Rezoning Transportation Analysis

Petition Number: #2022-087

General Location Identifier: 04715204, 04715205, 04715206, 04715208

Date	Description
11-28-22	First Review (TM)
12-22-22	Second Review (DR)

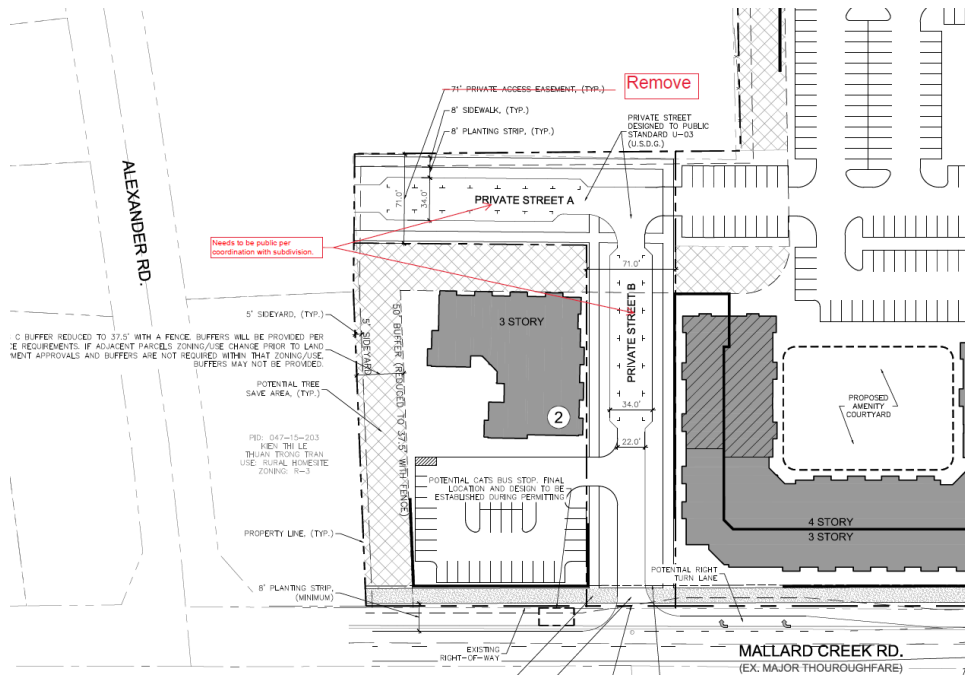
Clarifying comment from 12/22/2022: Private Street A and Private Street B will both need to be public streets per coordination with subdivision. Remove all references to private access easements for Private Streets A and B.

- New comment from 12/22/2022:** Modify median to ensure full movement for development adjacent can be retained from parcels 04715225 and 04715210. What is being proposed will create a change of access for the development adjacent to property.

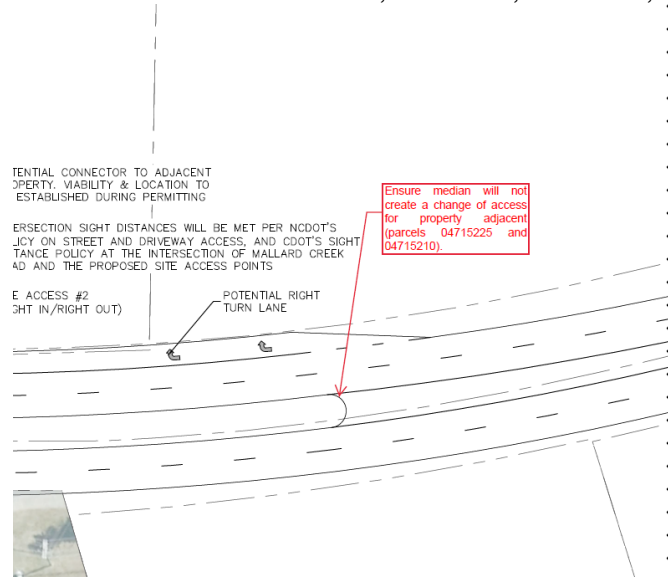
- 6. ~~The proposed dwelling units exceeds 12 per acre. Per Chapter 20 Subdivision ordinance, site plan and conditional note(s) revisions are needed to commit to construct an 8-foot planting strip, and 8-foot sidewalk along all internal public roads. The wider sidewalk also meets the Charlotte WALKS Policy.~~
- 7. ~~Revise site plan and conditional note(s) to commit to construct an 8-foot planting strip, and 12-foot sidewalk along the sites frontage per Chapter 19. The site plan shall label and dimension both items from the back of curb and gutter and road centerline.~~
- 8. ~~Revise site plan and conditional note(s) to commit to the southern site access as right in or right in/right out only. The northern site access at Colvard Park Way may be constructed as full movement. Site plan shall callout access restrictions of both site entrances.~~

~~Modify conditional note to specify that final design and location of southern driveway access will require additional coordination during permitting and may require infrastructure changes such as re-striping and/or concrete medians.~~

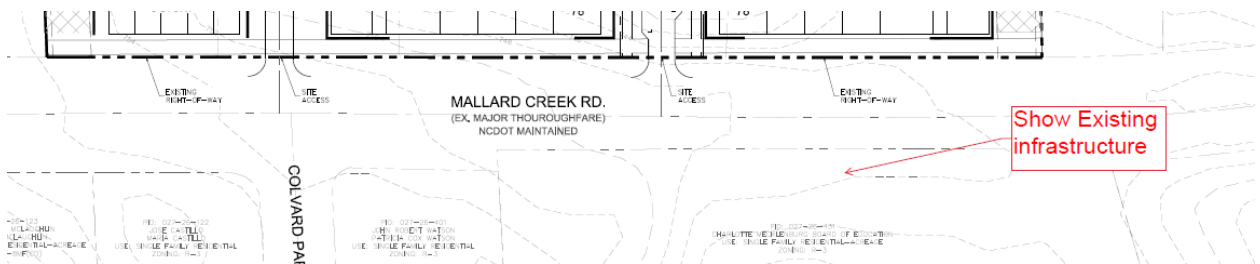
- 9. ~~Revise site plan by showing existing infrastructure along Mallard Creek Road including the existing driveways on the western side of Mallard Creek Road.~~
